## Land at Gosford

### Technical Note 13: Response to Active Travel England (ATE)

14<sup>th</sup> August 2023

Status		Status Date
Draft		April 2023
Drawn	Checked	Date
CL	AE	25.04.2023
Scale	Number	Rev
1:2000	10669-SK-07	A
04080120160200		
METRES

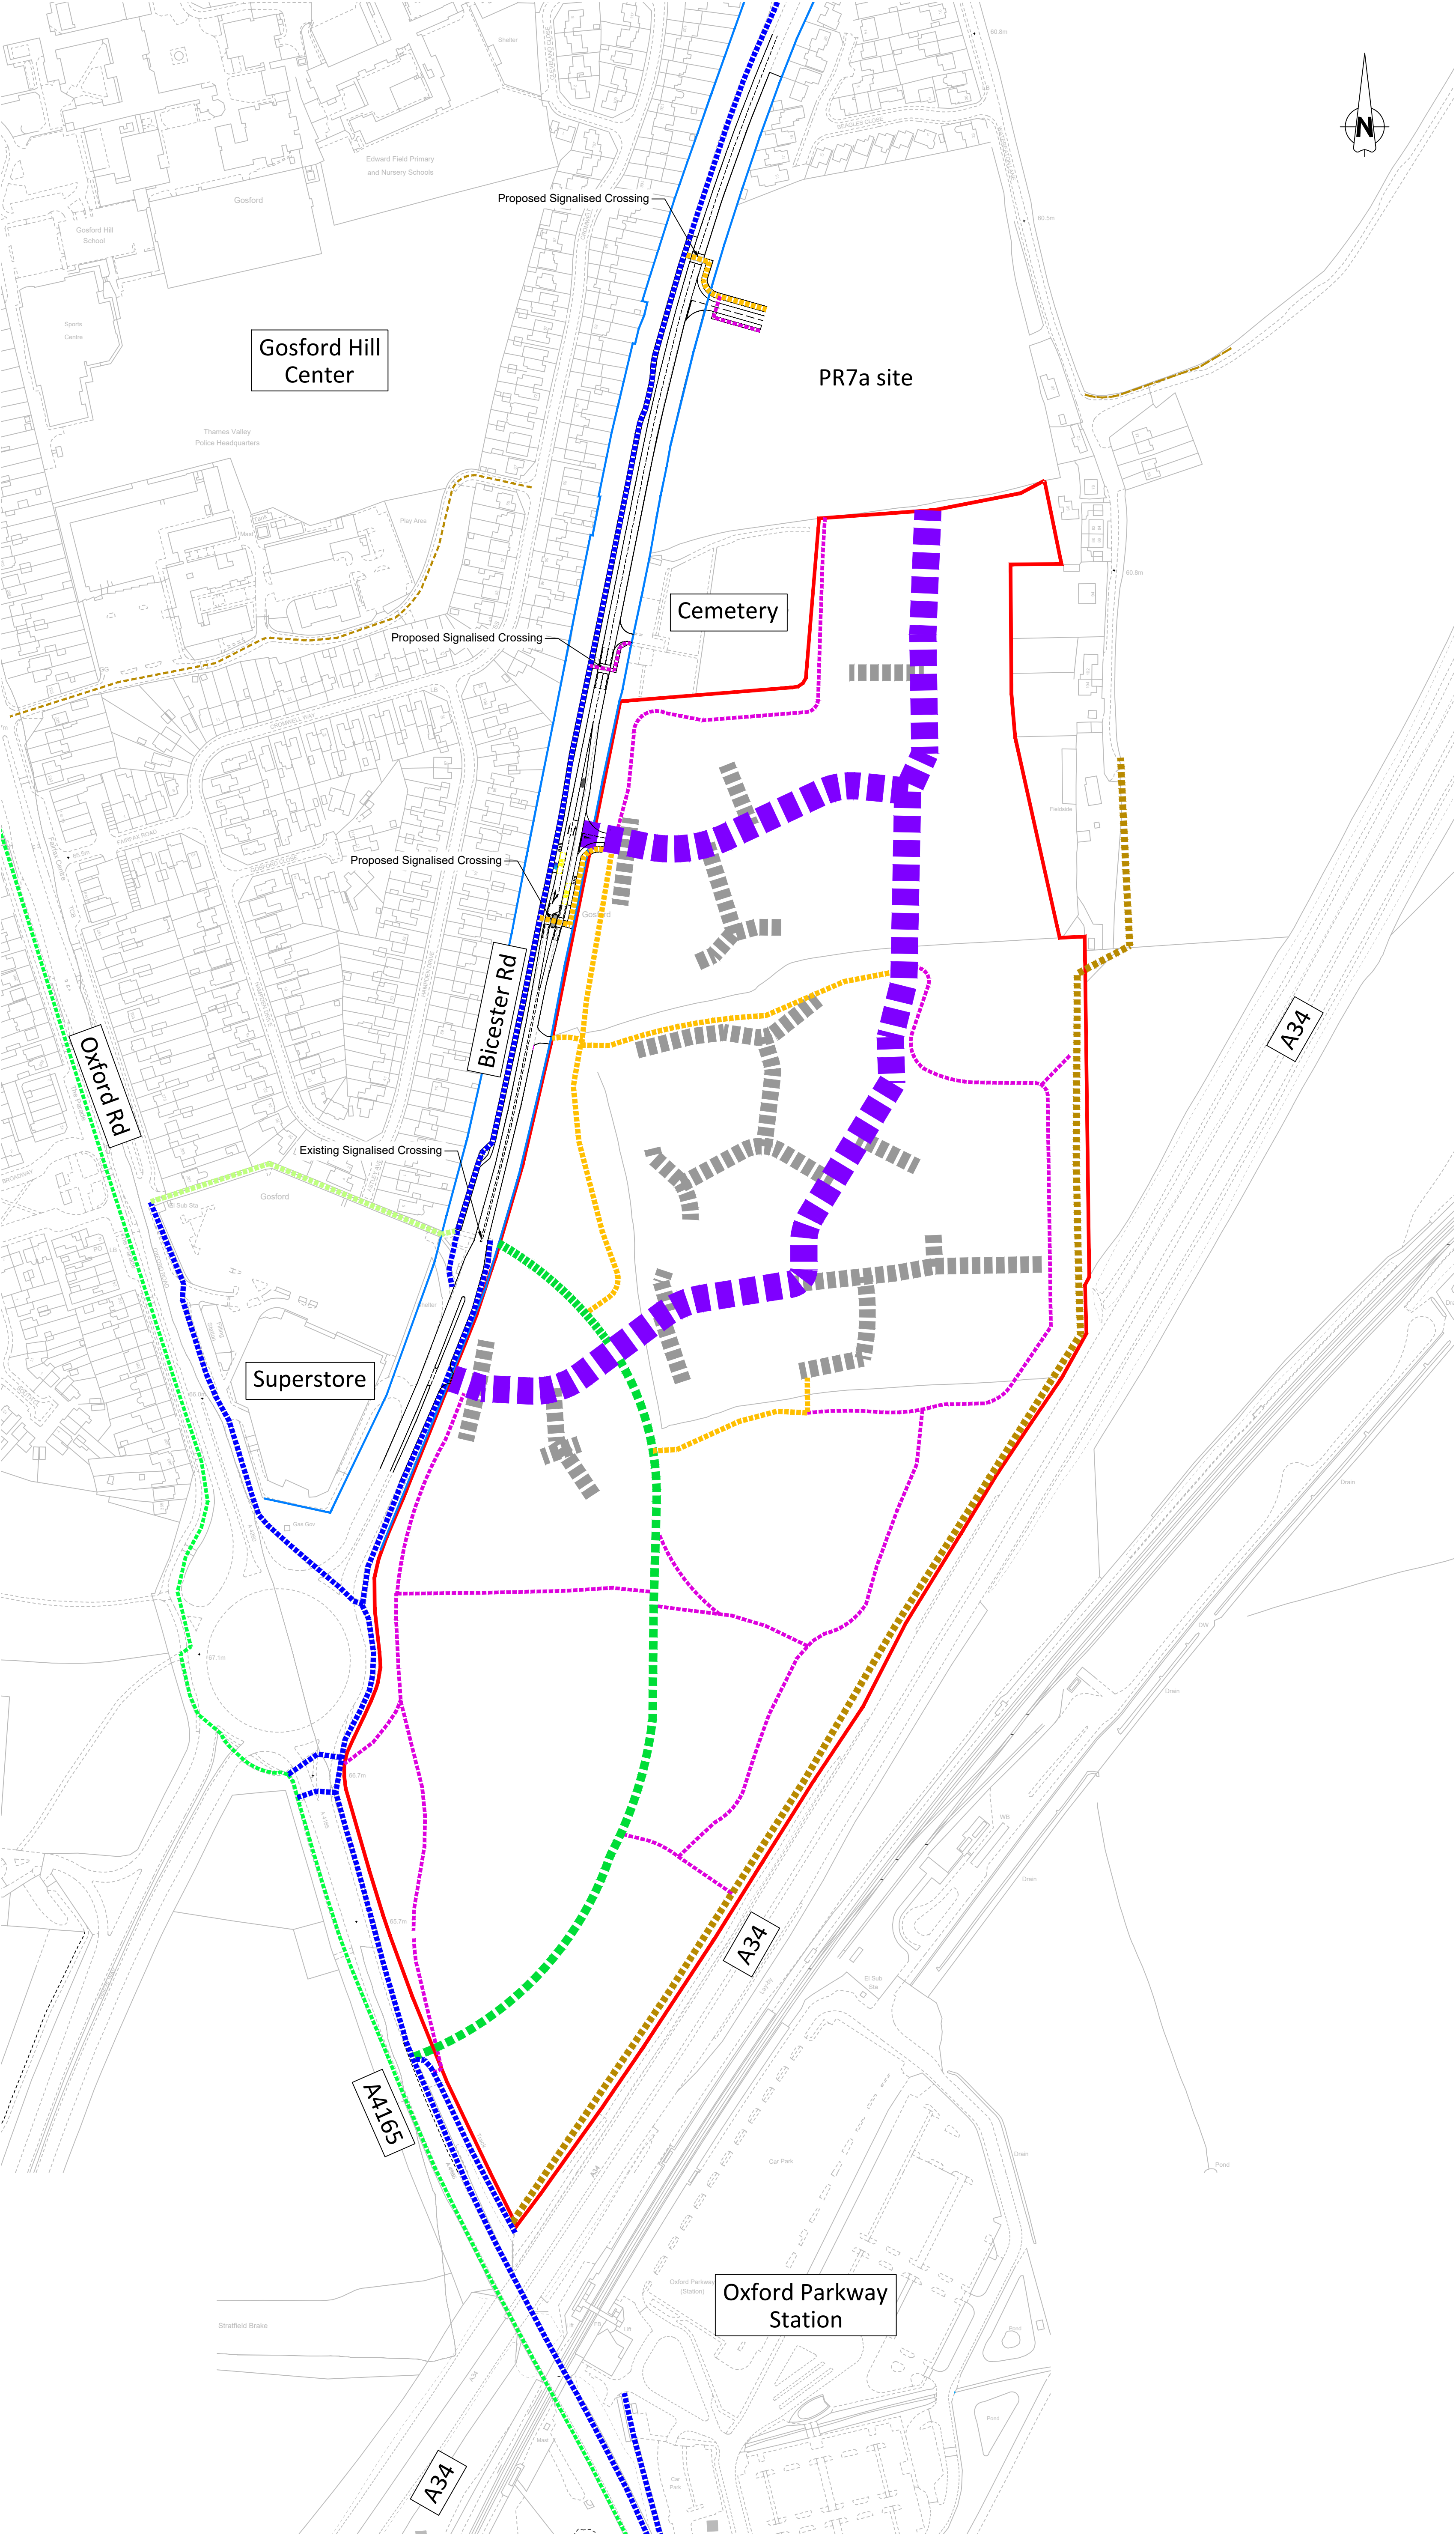
*ATE Comment: The Kidlington LCWIP identifies that future routes are intended to run through the site, along with the primary route along Bicester Road, as mentioned above. However, it is considered that the connections between Bicester Road and the Oxford Road require further thought, with particular attention to how they link with the site. This is essential in order to provide safe and convenient access for future residents to access the Sainsbury's supermarket and local amenities to the west. The public footpath that runs along the north side of Sainsbury's car park would appear to provide non-motorised access between Bicester Road and the Oxford Road and recommends a proportionate financial contribution is made to enhancing this route, along with the further cycling measures identified in Table 9 of the LCWIP.*

- 3.6** The application supports a comprehensive movement strategy that provides strong links into the existing infrastructure. This includes provision of crossing facilities along Bicester Road, links into the Greenway and a continuous route towards Oxford Parkway. These details are included within the TA Addendum (paragraph 3.8) with an overall movement plan included within **Appendix B**.

- 3.12** The connections between the Application Site and Bicester Road / Oxford Road are shown on the plan contained in **Appendix B**. This confirms that a movement strategy has been developed to ensure the future residents can safely access the existing facilities within Kidlington. Discussions are ongoing with OCC in relation to the proportionate financial contributions that are necessary.

Drawing Number	Status	Rev
P1B-ATK-HAC-XX-SK-CH-000001	S2	P01

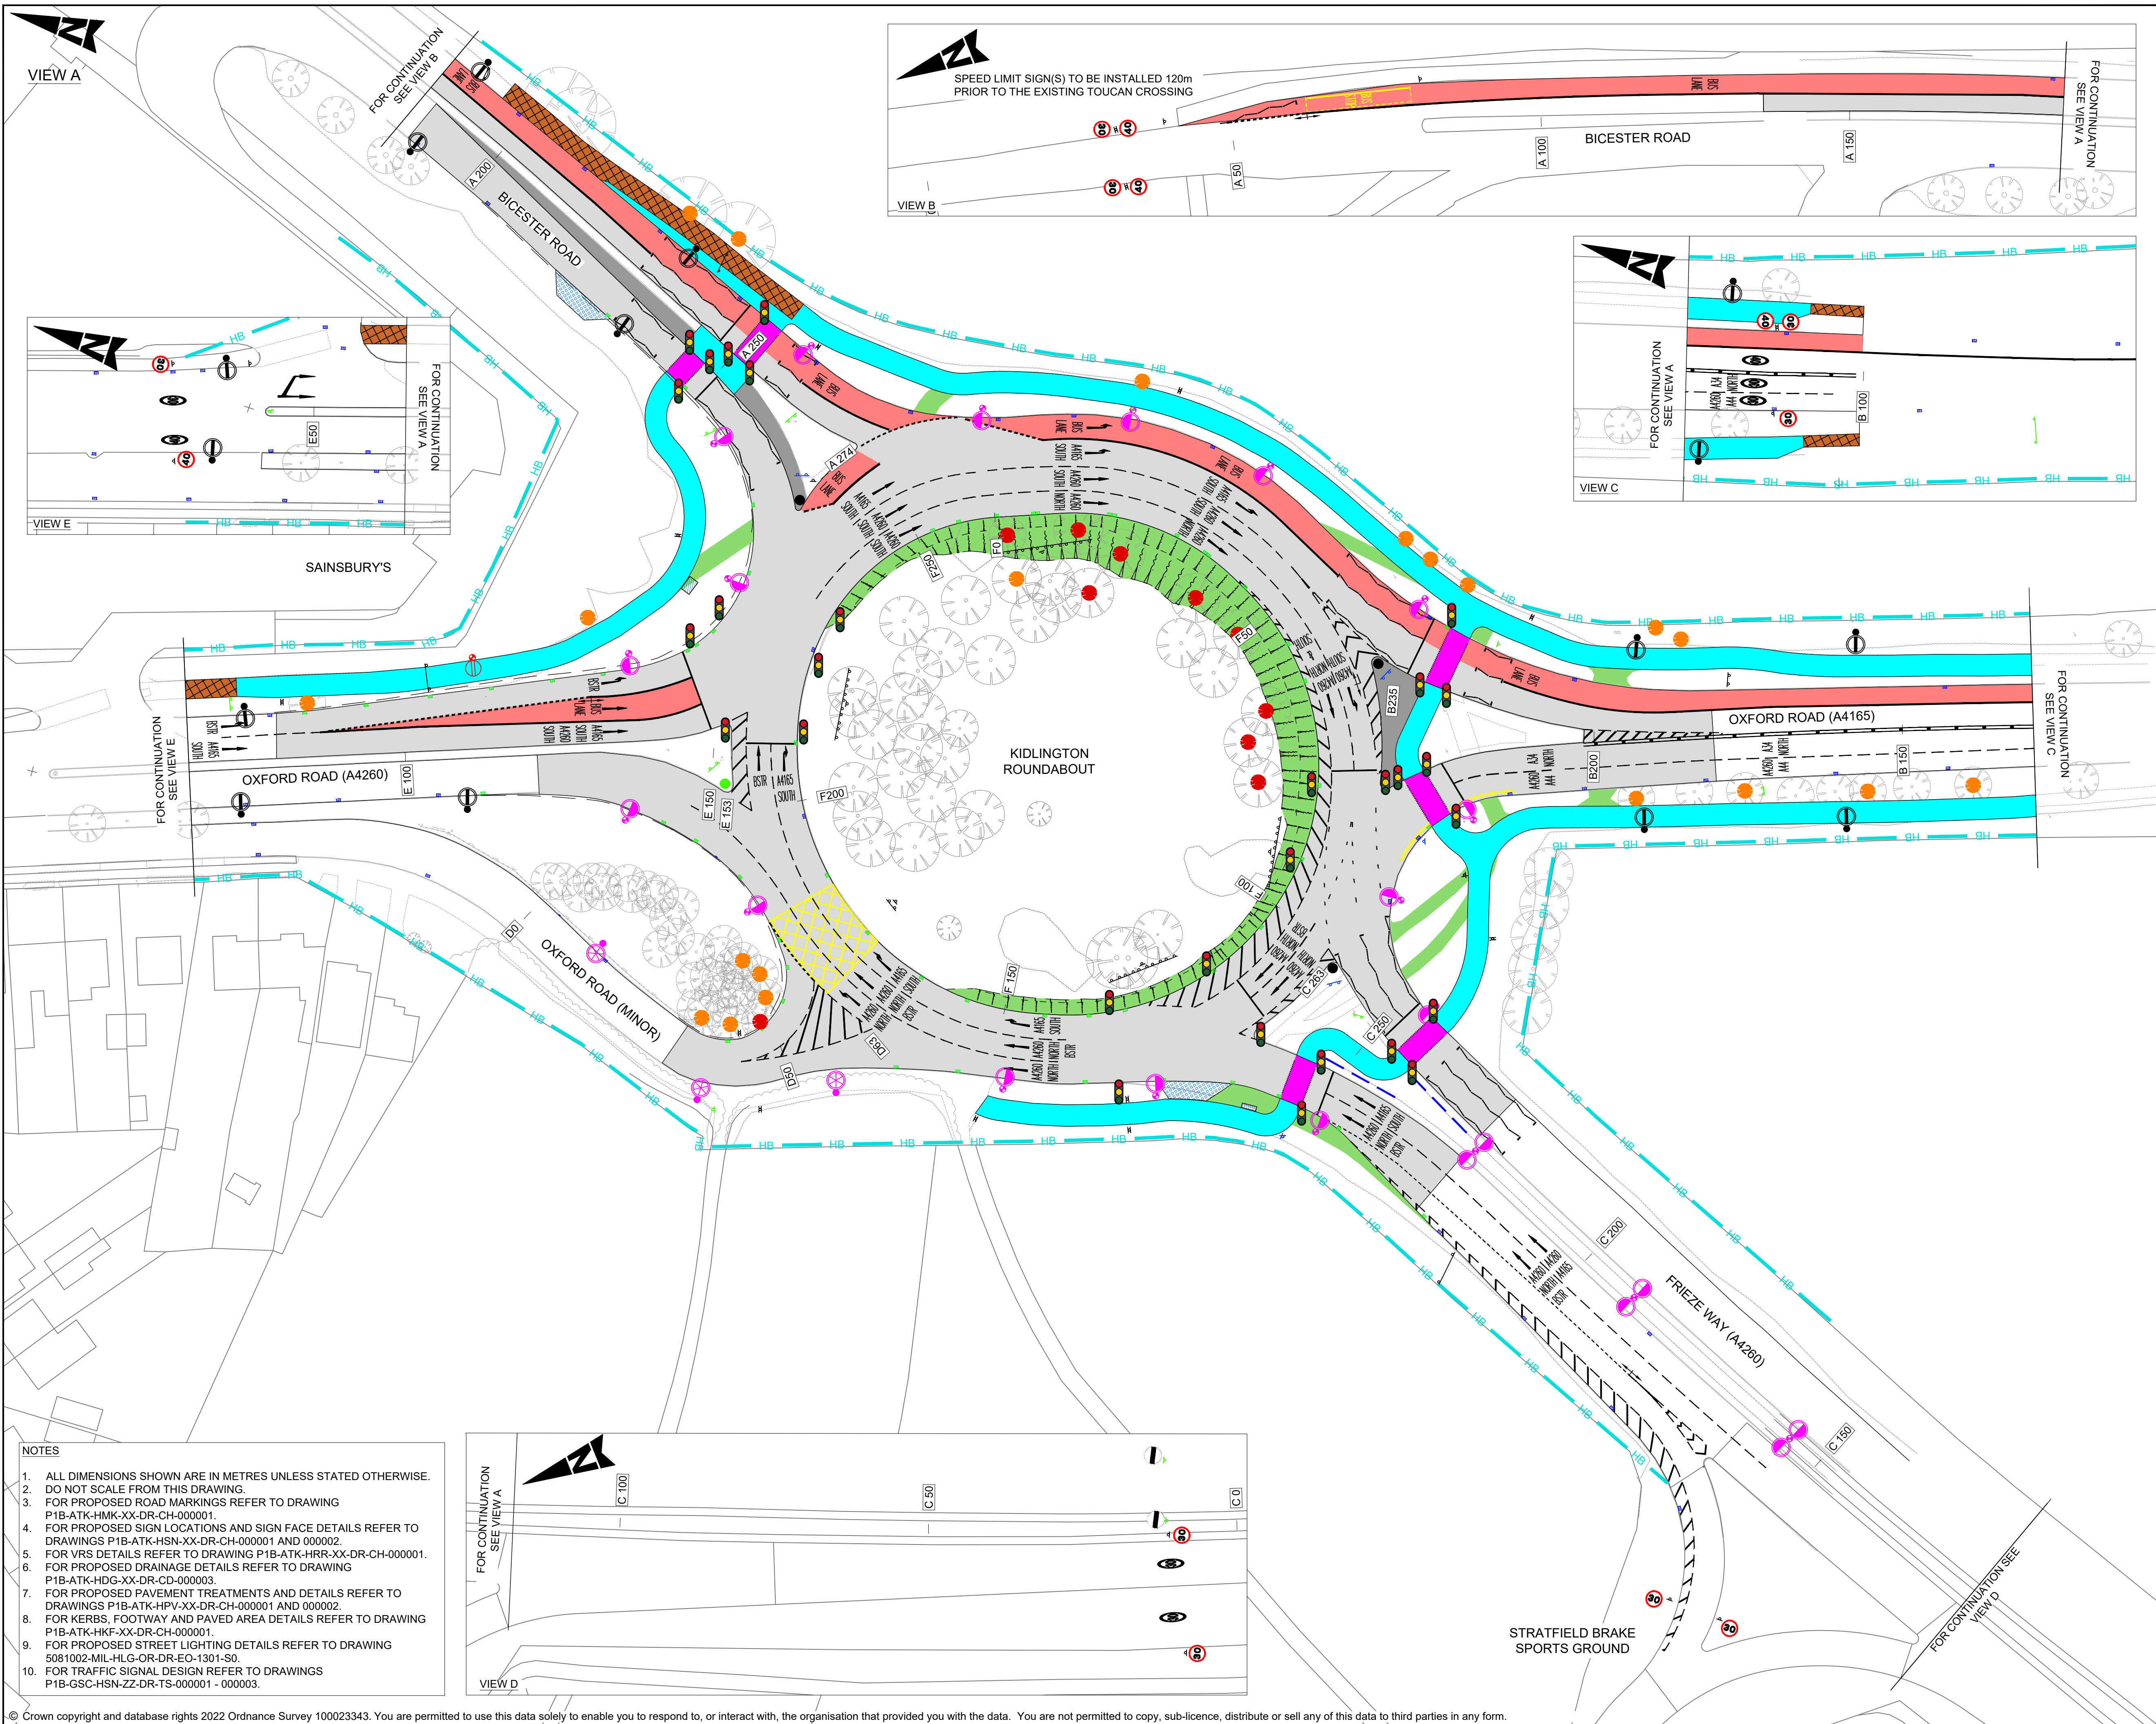
*ATE Comment: Concerns are raised about the suitability of the Oxford Road / Bicester Road roundabout, particularly for cyclists' use. It is therefore recommended that improved segregation be provided to ensure safety across the roundabout, including suitable crossings for all users in line with LTN 1/20. It is crucial that these matters are addressed to achieve sustainable development through the provision of attractive, safe and direct routes for non-motorised users - a commitment that is pledged within the Planning Statement at paragraph 2.10.*

*ATE Comment: The data presented in the Transport Assessment identifies two collision clusters on the roundabout approaches from Oxford Road and Bicester Road with four collisions recorded on each arm, two of which were severe injuries, with all eight involving cyclists. Consequently, and in consideration of the wider growth proposed for the area, it is recommended that these issues are addressed, with a solution for safe and attractive infrastructure progressed through the obtaining of developer contributions in line with the NPPF and Local Plan Policy PR4a (Sustainable Transport).*

- 3.4** Improvements to the Oxford Road / Bicester Road have already been identified by OCC. The improvement scheme will provide a safer walking / cycling environment, the scheme is contained within **Appendix C**. These improvements are part of a comprehensive package of measures that is identified within the Infrastructure Delivery Plan. The TA Addendum confirms (paragraph 3.20 and paragraph 4.3 of 10669TNH11vRev1) that the Applicant will make a proportional contribution towards the IDP, in line with the other PR sites which reflects the advice from OCC. The IDP is contained in Appendix 4 of the Cherwell District Council (CDC) Local Plan Partial Review.

- 3.11** As indicated previously, OCC have developed a package of improvements at the Oxford Road / Bicester Road junction which will include the delivery of cycling infrastructure which will fundamentally assist with the safe movement of cyclists through this junction. The improvement scheme is contained within **Appendix C**.
